**MINUTES
TOWN OF AMHERST
DESIGN ADVISORY BOARD MEETING
December 12, 2024
6:00 PM**

- 1.1. DESIGN REVIEW, SP-2024-09; PROPOSED RESTAURANT WITH DRIVE-THRU (7 BREW)
Property Located at 3999 Maple Road
Mannik & Smith Group, Inc., Petitioner

RESPONSE LETTER TO REVIEW COMMENTS

1 EXTERIOR ELEVATION - EAST (N. BAILEY AVE.)
3/8" = 1'-0"

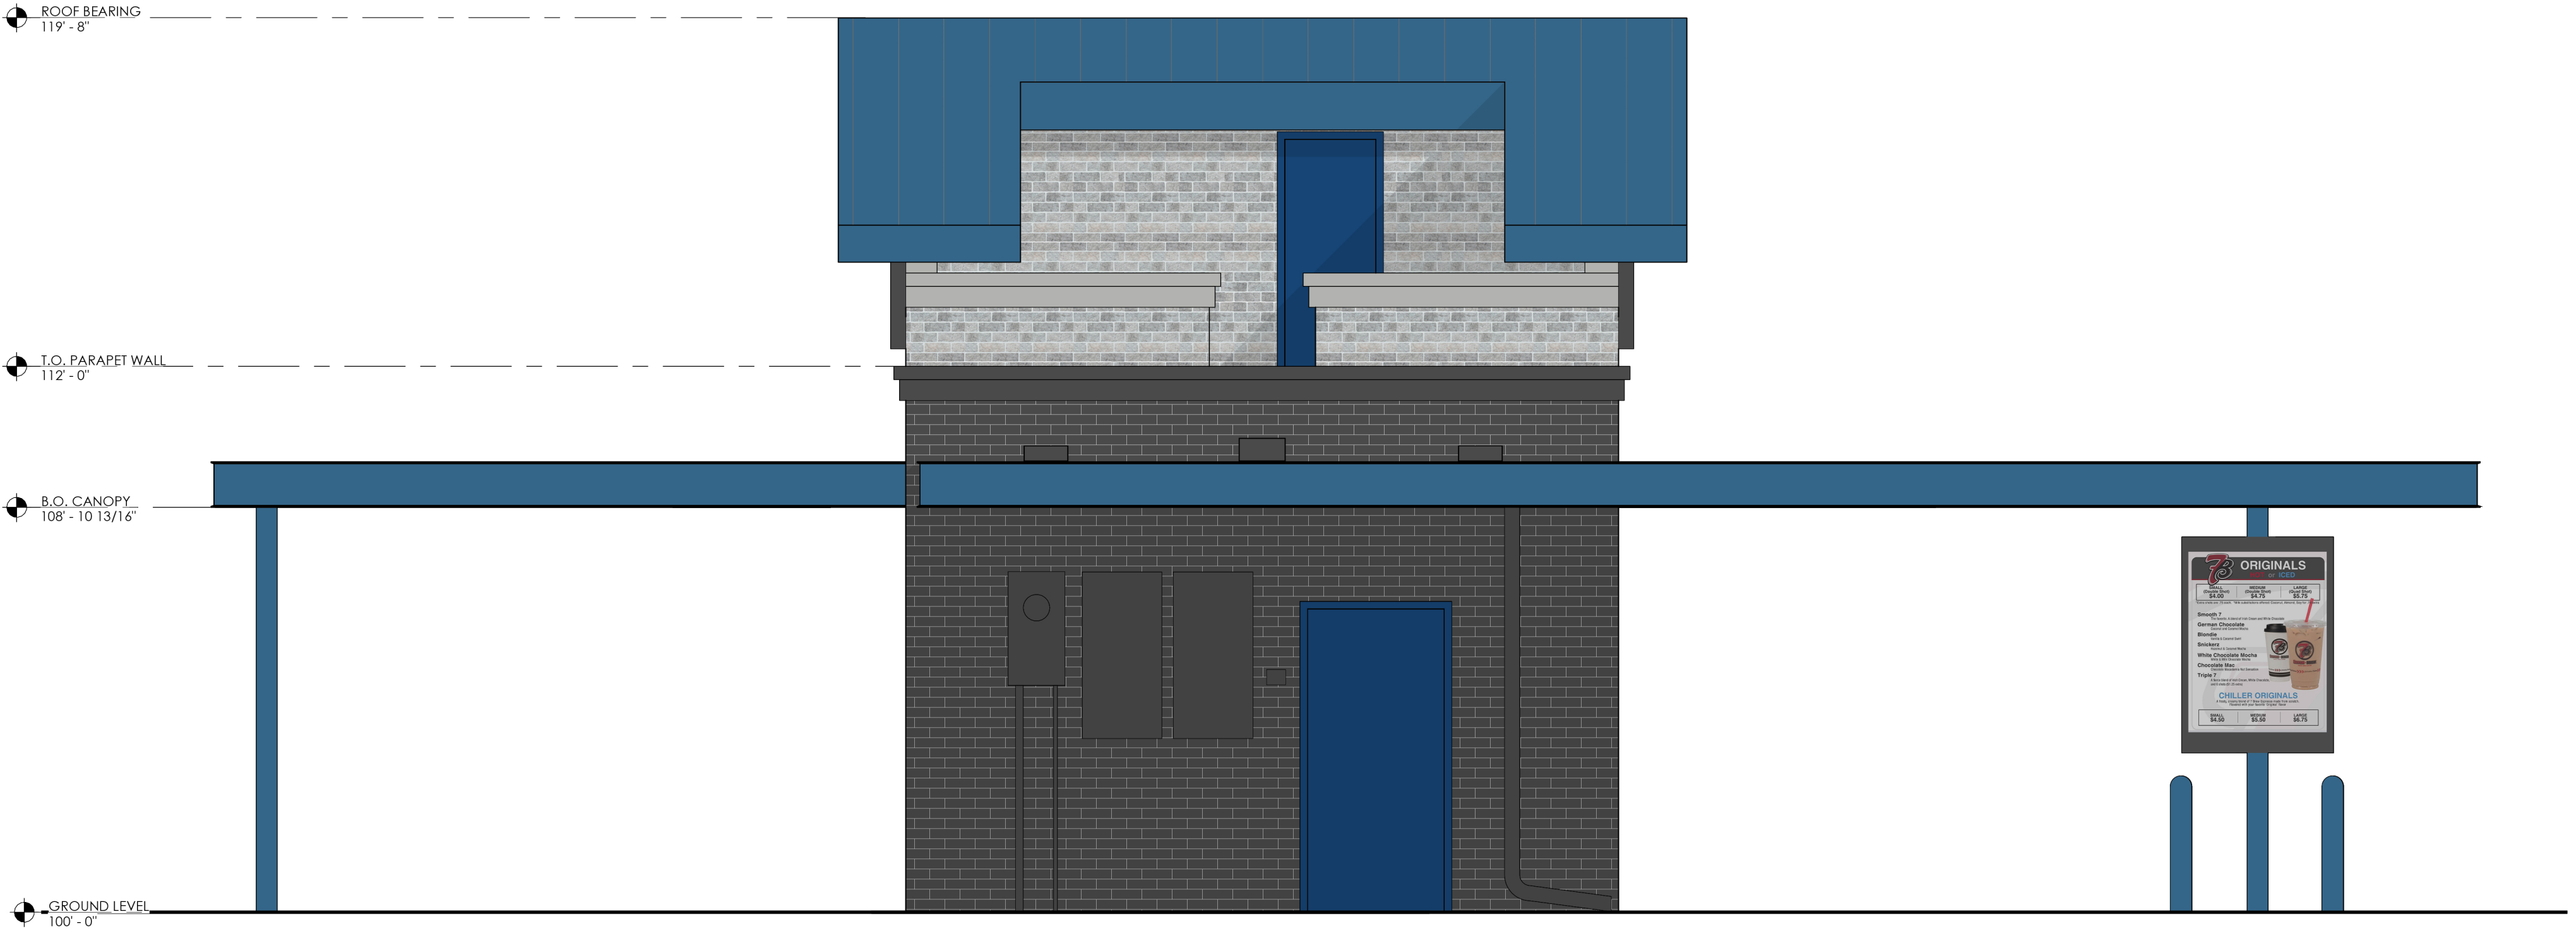
Ms. Colucci noted the northern bench should be moved beneath the canopy to be protected from weather. Also, with various elevations for the multiple materials, she recommended the cornices of the cooler building be heightened to match those on the main building. Finally, she asked for clarification regarding the windows on the cooler building. Mr. Harden confirmed they are spandrel, which should screen the machinery. Gary Palumbo, Associate Planner, noted that the petitioners are seeking variances from the Zoning Board of Appeals from transparency and height requirements.

The cornices of the main and cooler buildings should match in style and height.

Response: Cornices have been added to the cap, please refer to updated color elevations.

1 EXTERIOR ELEVATION - NORTH (MAPLE ROAD)
3/8" = 1'-0"

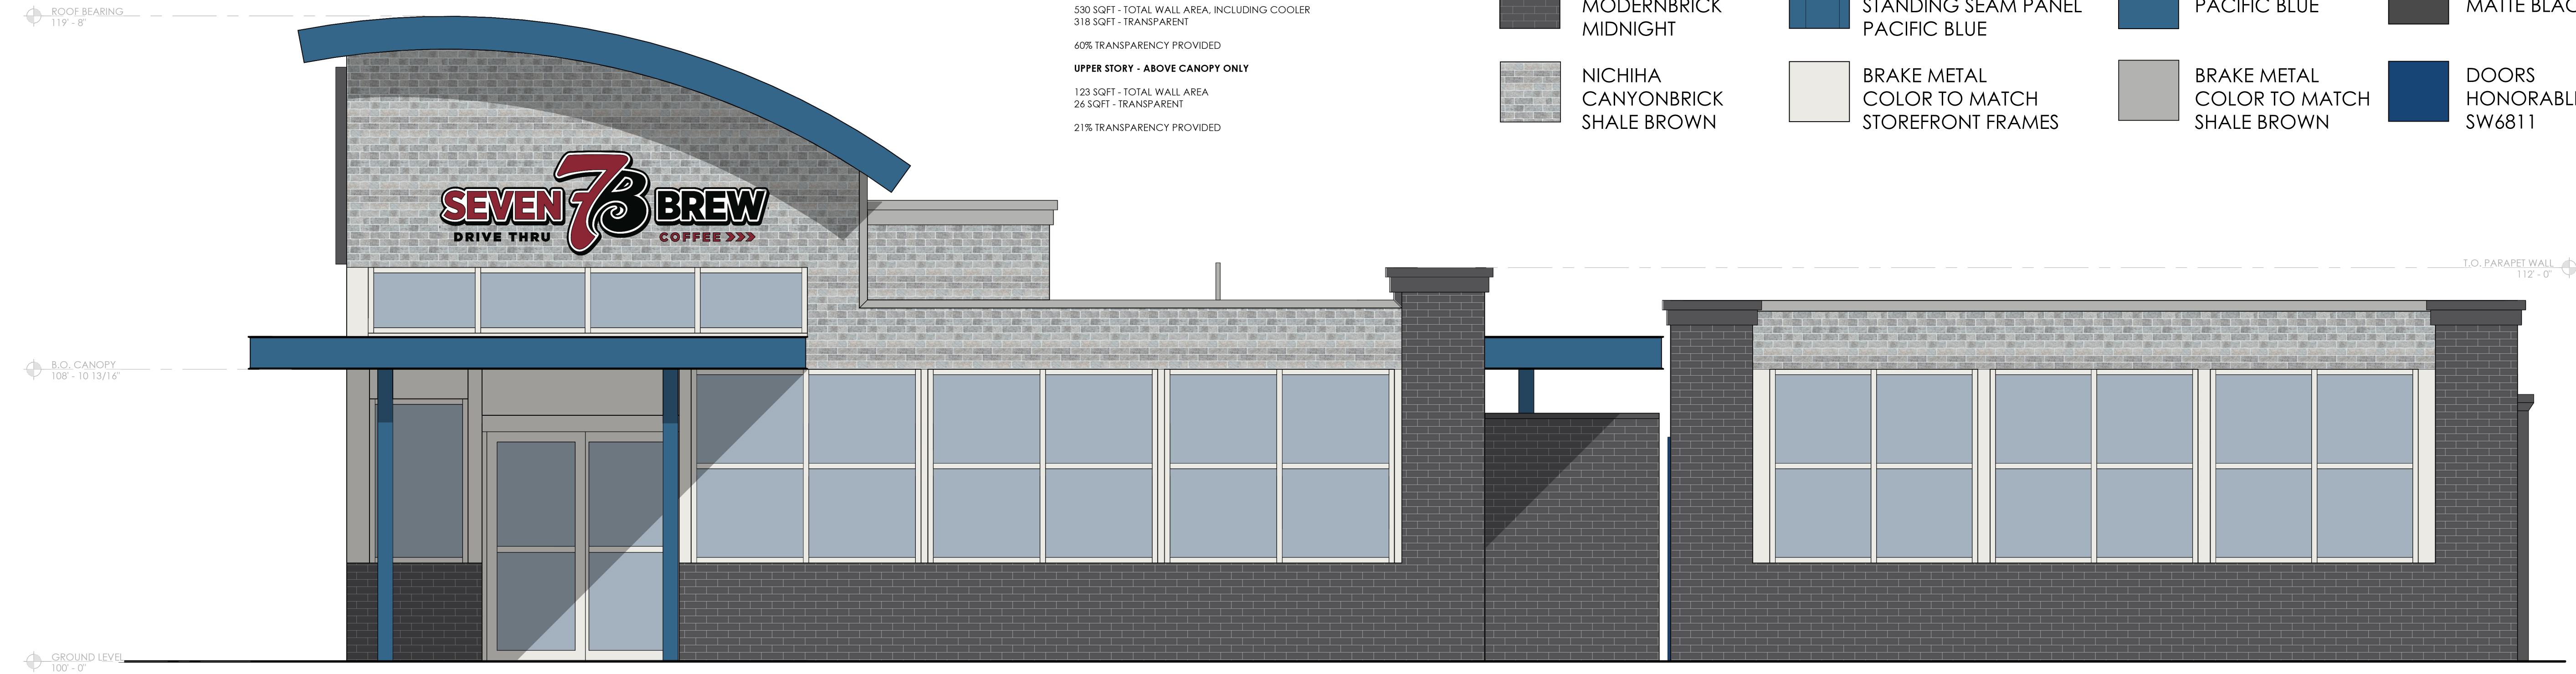
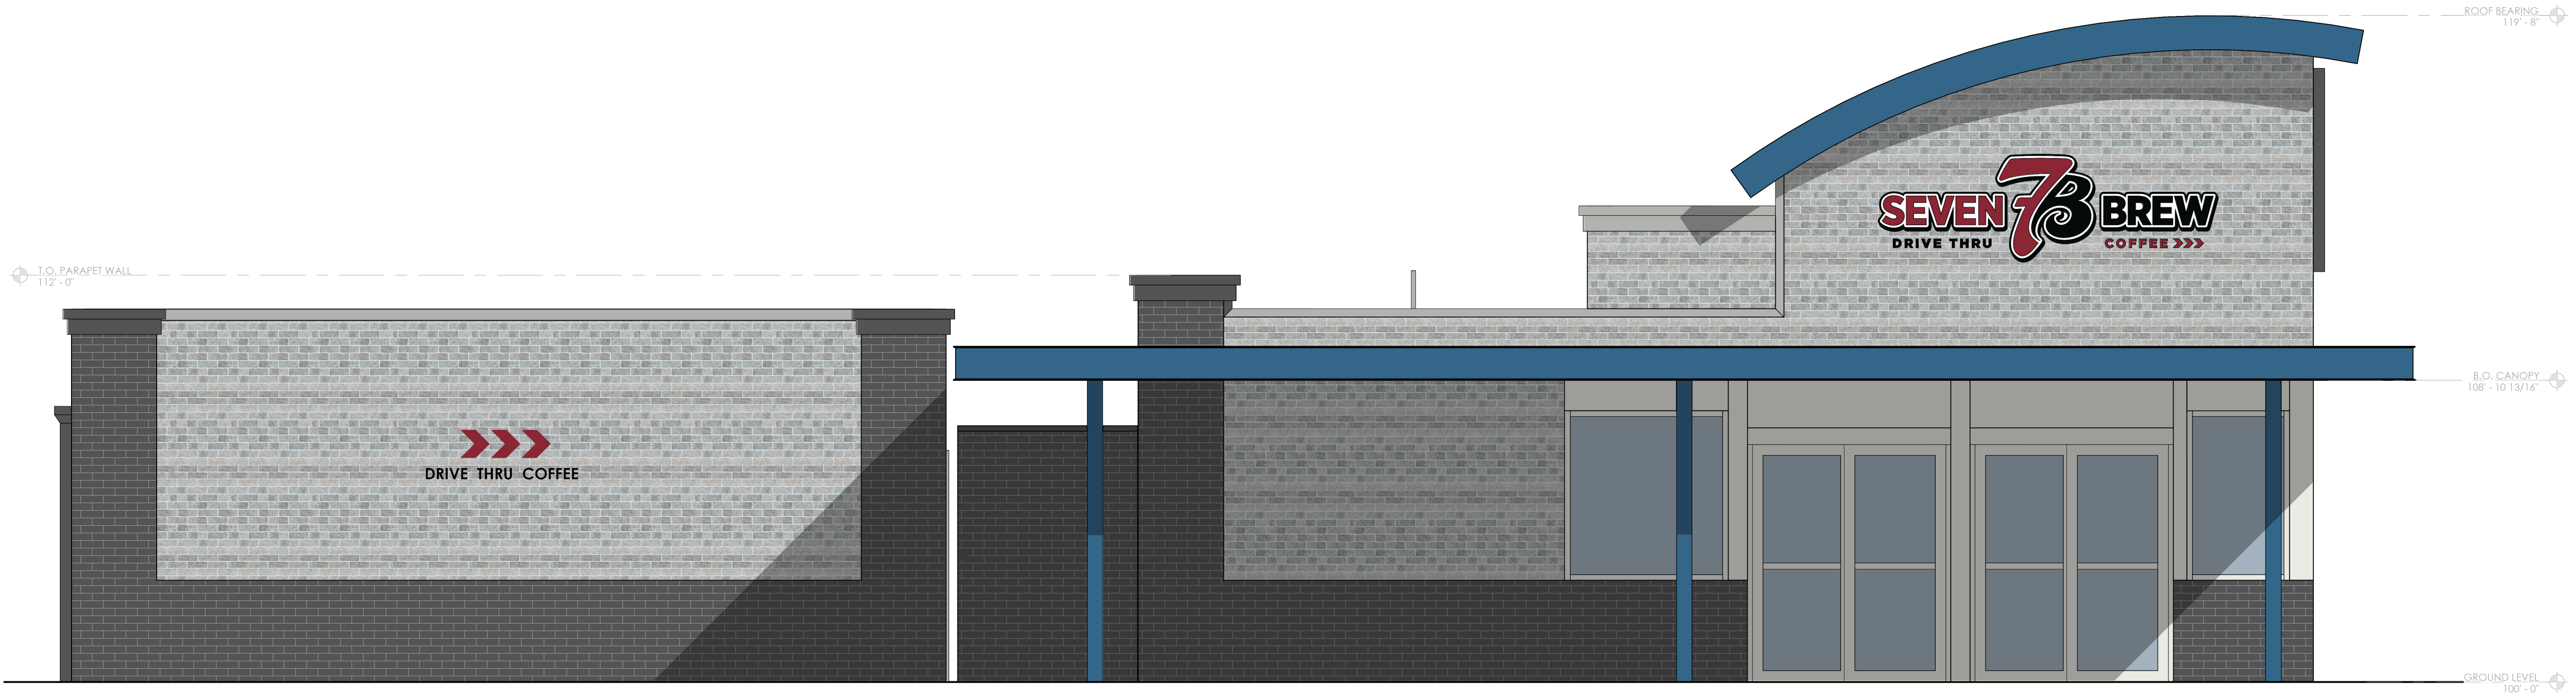
1. The plans include a bench on the north side of the building under the canopy.
2. The plans include pedestrian-oriented directional signage to enhance the identification and of the walk-up window.
3. The building plans provide cornices on the cooler structure to match (in height) cornices on the main building.
4. The plans provide a sidewalk serving parking spaces be extended to provide safe pedestrian access between the building and parking spaces.
5. The internal circulation be enhanced with signage and/or pavement markings to avoid turning conflicts in the one-way circulation pattern.
6. The inclusion of a custom coffee-centric artistic bike rack be included in plans.
